Triumph

CYLINDER HEAD TORQUE AT PDI

TR7

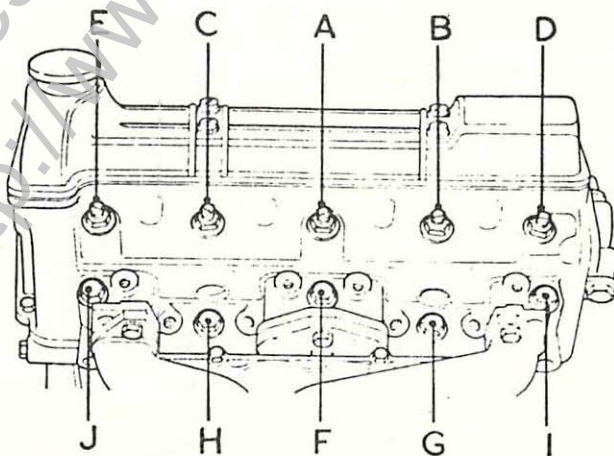
It has been established that to correctly torque the cylinder head retaining nuts and bolts at the pre-delivery inspection will prevent premature head gasket failure.

To avoid distortion of the cylinder head, it is important to follow the correct tightening sequence which is as follows:

A, B, C, D, E, F, G, H, I, J (SEE DIAGRAM)

When releasing the nuts and bolts prior to removing the cylinder head, the above sequence must be reversed, i.e.:

J, I, H, G, F, E, D, C, B, A

Please note when checking the torque loading of the nuts and bolts they should first be slackened off to overcome static friction and then retightened to the correct torque figure of 45/55 lbs. ft.
